doc.: IEEE 802.11-99/115

## Proposal for an improved long training symbol phase

Clause number; 17.3.3 PLCP preamble (SYNC)

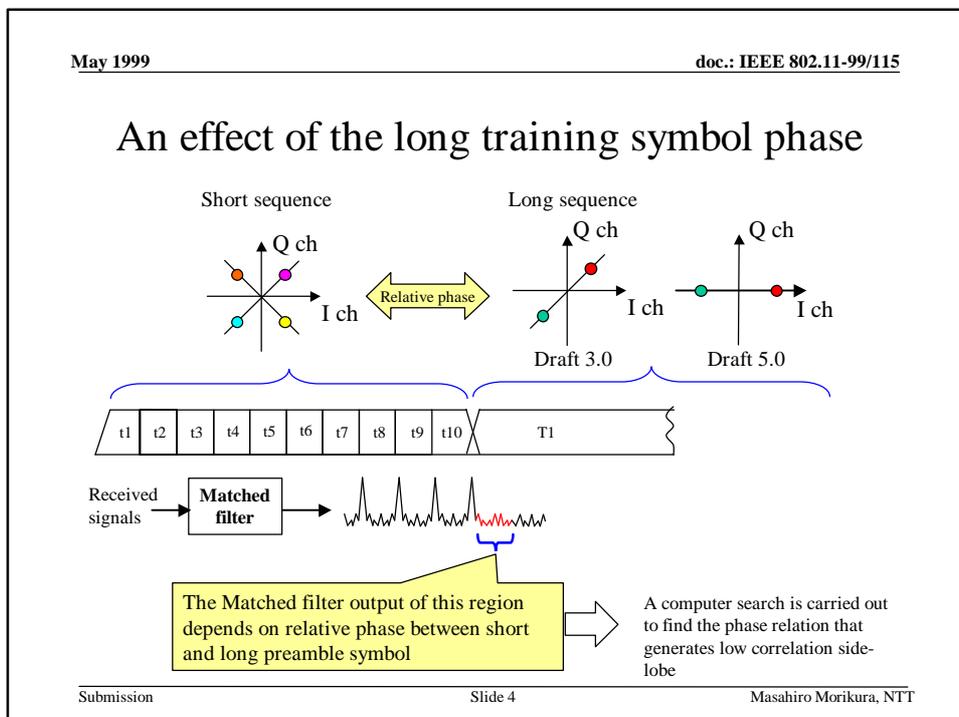
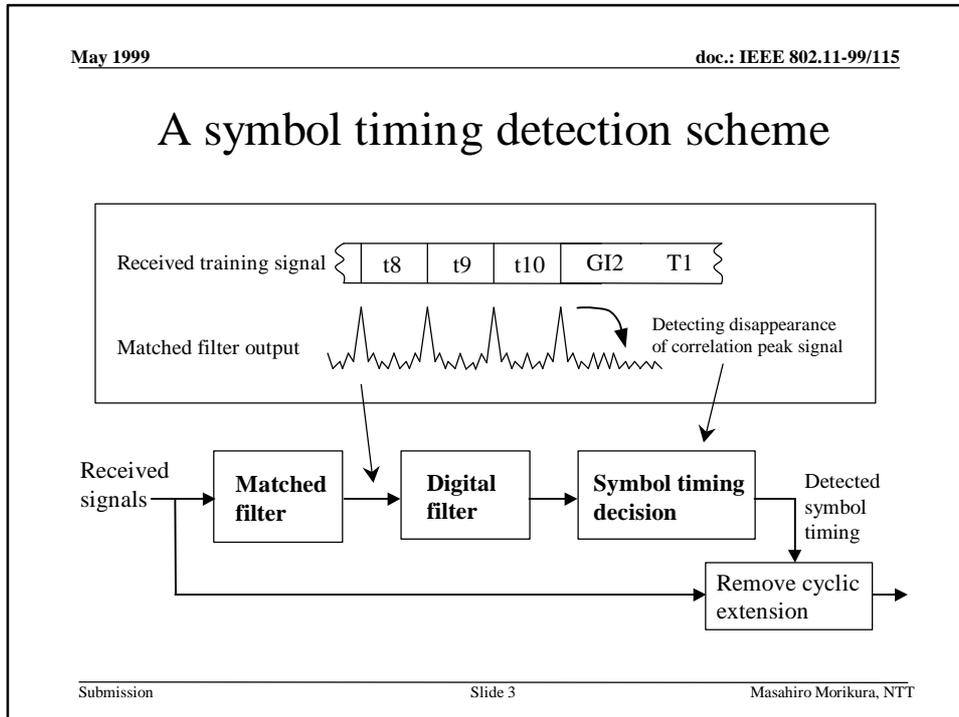
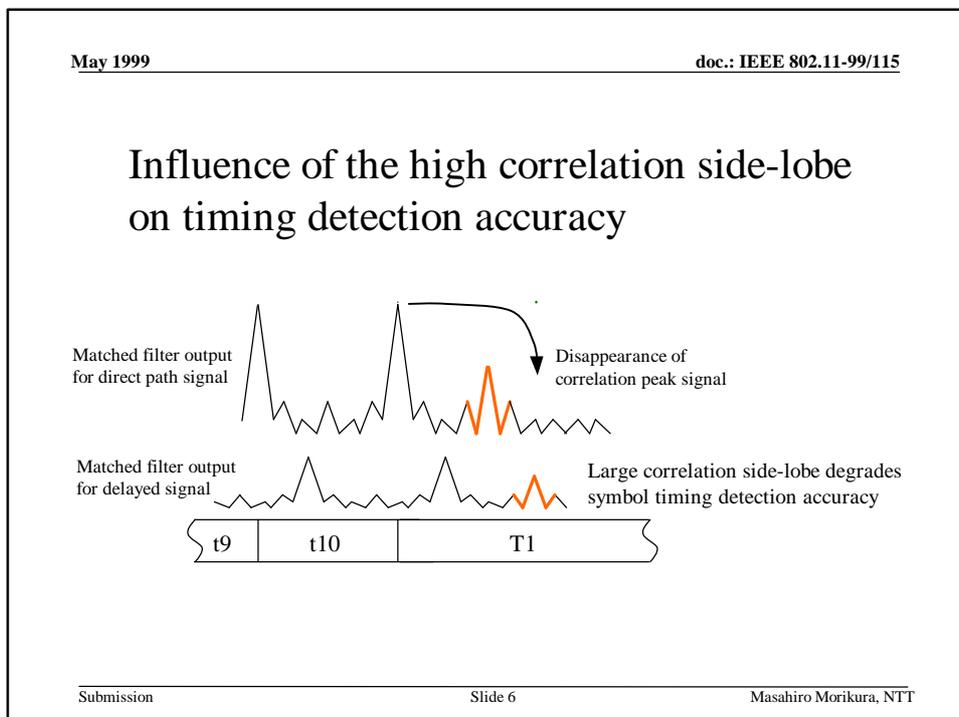
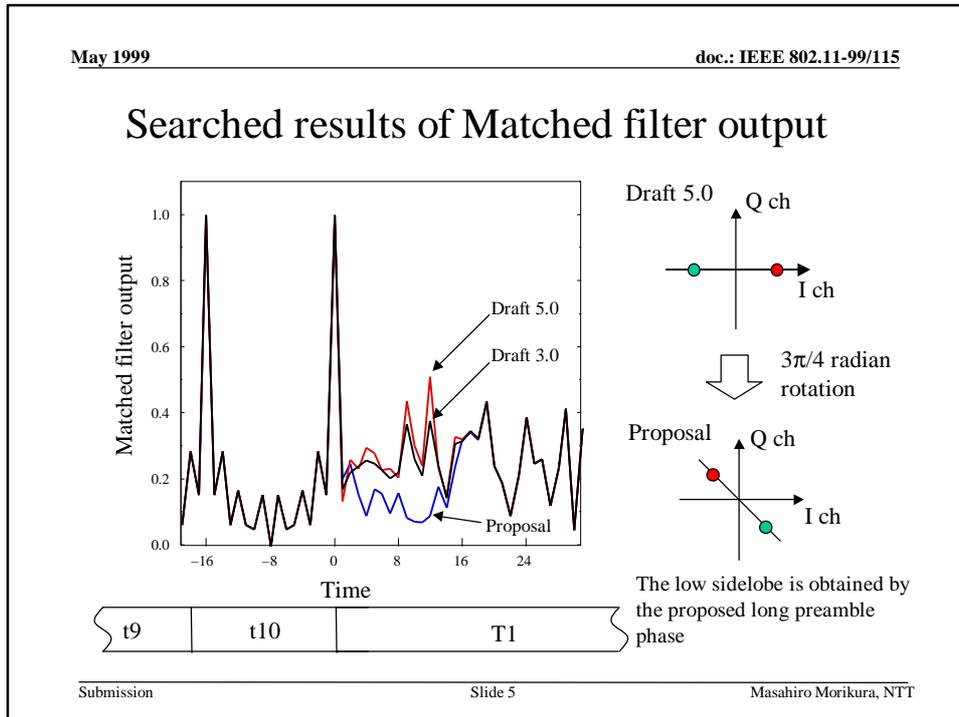
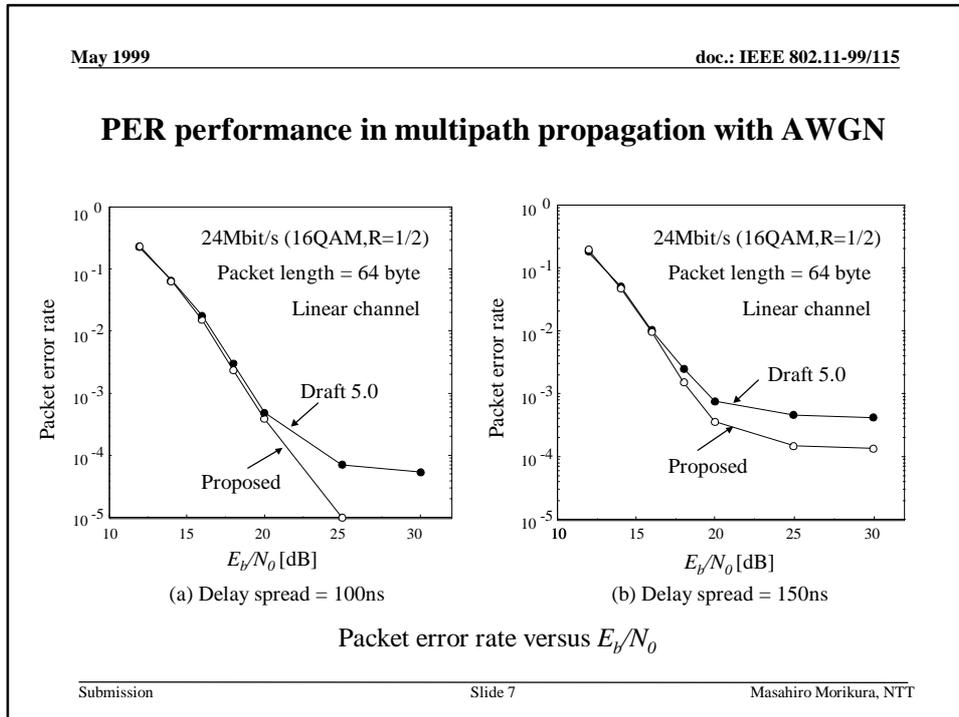
The phase relation between short preamble (t1-t10) and long preamble (T1,T2) in draft 5.0 causes degradation in timing detection accuracy. This is because the matched filter output for detecting the short preamble pattern has large side-lobe in boundary region between t10 and T1 when the phase relation in D5.0 is used. This large side-lobe badly affects the timing decision value when multi-path delayed signals are superimposed.

- A search was carried out to find the long preamble phase that gives low correlation side-lobe.
- Recommendation :  
 Change Eq.(8) so as to rotate the all signal phase  $+(3/4)\pi$   
 $L_{-26,26} = \{-1+j, -1+j, +1-j, +1-j, -1+j, -1+j, +1-j, -1+j, \dots$   
 $\dots, -1+j, -1+j\}/\text{sqrt}(2.0)$

- By only changing the preamble phase, the irreducible packet error is improved to less than 1/3 that of Draft 5.0
